SERVICING INFORMATION ADDENDUM

MODEL 3011B FUNCTION GENERATOR

PORTION OF SCHEMATIC DIAGRAM CHANGED:

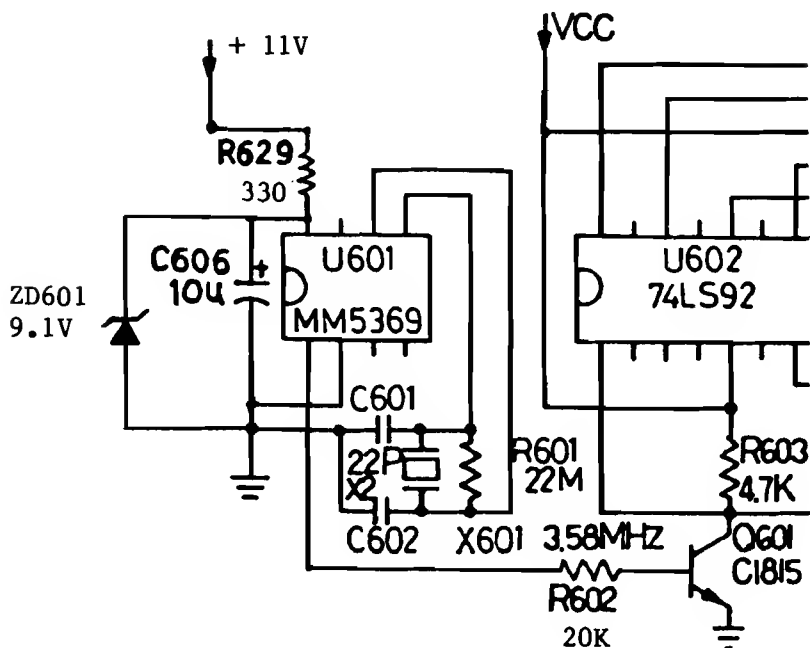
Effective with serial no. 147-30253, Model 3011B has been factory modified to add ZD601 and change the values of R602 and R629. Use the schematic diagram and parts list information in this addendum for servicing units after serial no. 147-30253.

R602	20 kΩ ± 5%, 1/4 W carbon film resistor	002-104-5-203
R629	330Ω ± 5% 1/4 W carbon film resistor	002-104-5-331
ZD601	9.1 V, 500 mW Zener Diode	152-207-9-001
